Project No. 21101

**Re: PA22-024- Marysville 44th PRD – Technical Review 3  
7315 / 7417 44th St NE – APN(s) 30053500303700 / 30053500303600**

This letter is provided as response to comments dated May 16, 2023. Each item has been carefully reviewed and considered and the following is a summary of how each item was addressed.

Exhibit 1310-20 Right-Turn Pocket and Right-Turn Taper

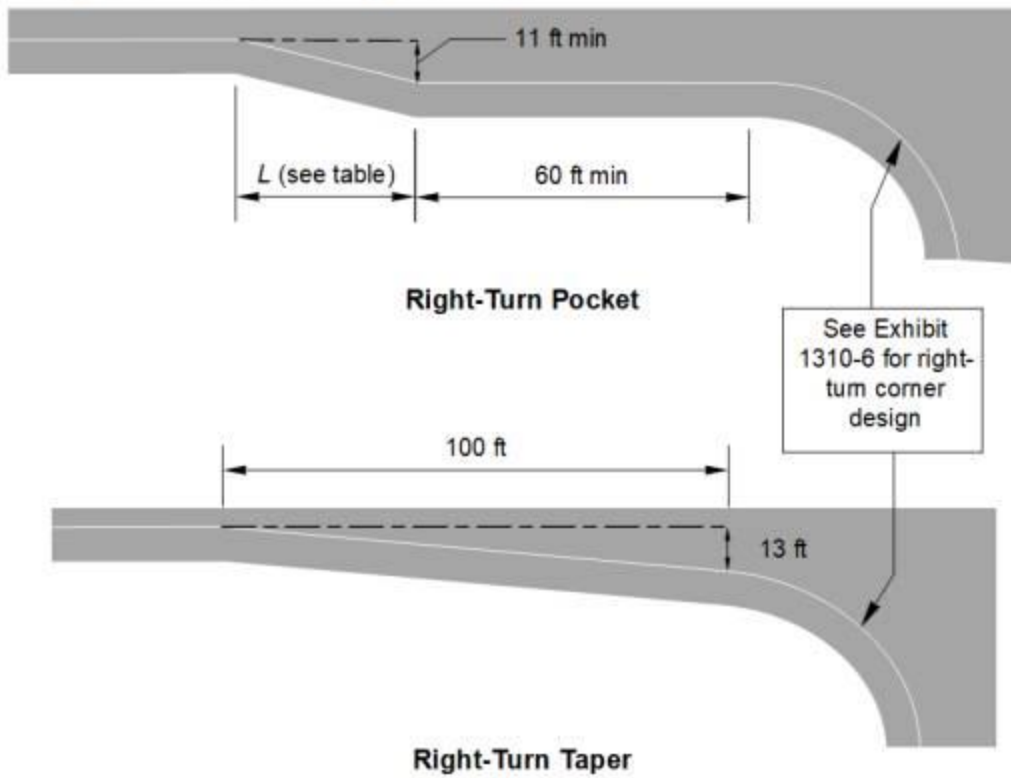
- a. The westbound right-turn deceleration lane on 44th St NE shall be consistent with WSDOT's Design Manual (DM) Exhibit 1310-21 to mitigate sight-distance. The multiplier for downgrade shall also be evaluated.

A WB motorists slowing to turn right is not stopped thus the sight distance for a WB motorist behind the turning motorist is substantially less than what is needed for stopped motorist (for example a motorists waiting to turn left). Thus, I believe the City's requirement for a Right-Turn Deceleration Lane is not needed. However, based on my further review changing the Right Turn Taper to a Right Turn Pocket and adding a W2-2 Warning sign per applicable MUTCD requirements would make sense.

***Per consultation from Mark Jacobs, PE, PTOE, a right turn pocket, per WSDOT Exhibit 1310-20, is more appropriate for the situation. The existing design has been updated to meet the dimensional requirements of Ex 1310-20, right turn pocket, with a 60' pocket and***

**a 40' taper. A W2-2 side road warning sign is also proposed east of the Site to warn approaching vehicles of the intersection. See attached correspondence and guidance from Jake Traffic Engineering, Inc.**

## Exhibit 1310-19 Right-Turn Lane Guidelines

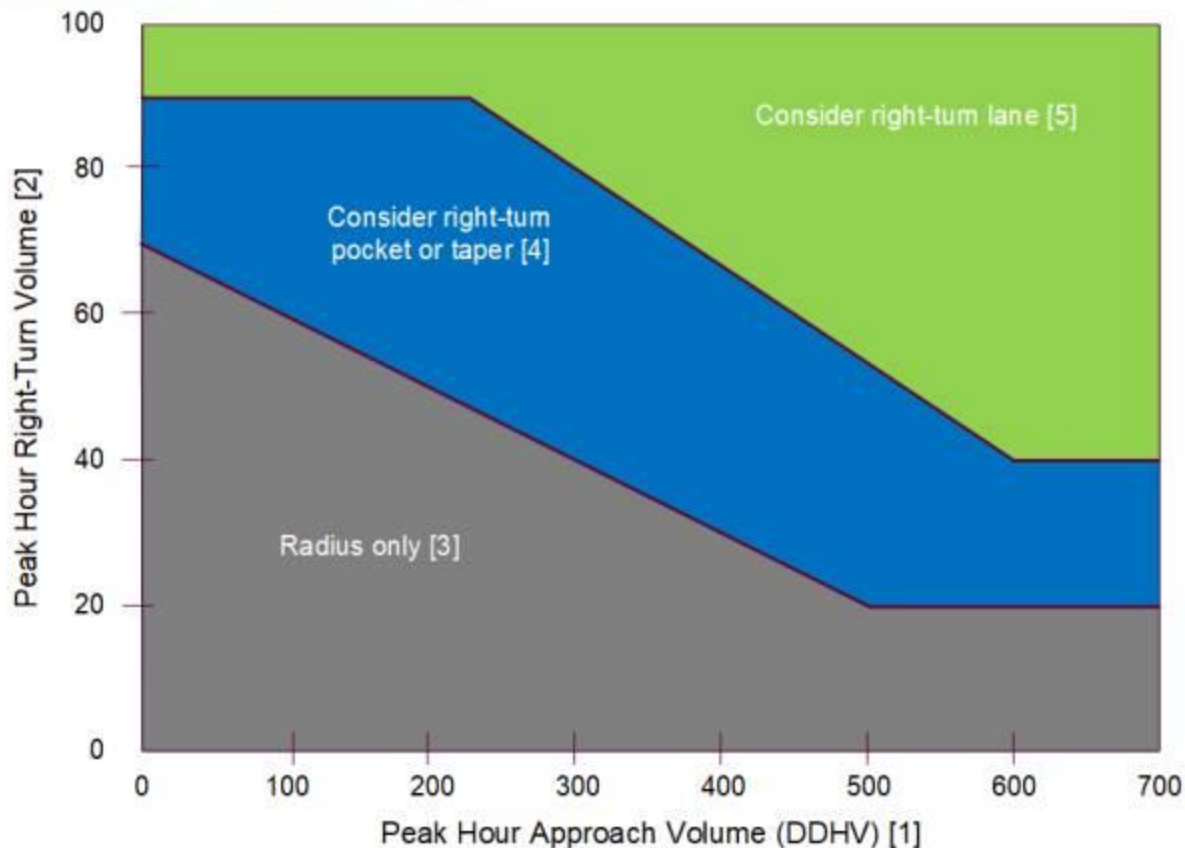
Per Exhibit 1310-19 Right-Turn Lane Guidelines and the available traffic data and my experience the consideration of a right-turn pocket or taper is noted. In my Conceptual Plan I had noted a Right-Turn Taper. 44<sup>th</sup> St. NE is a 2-lane street with a 35 MPH speed limit
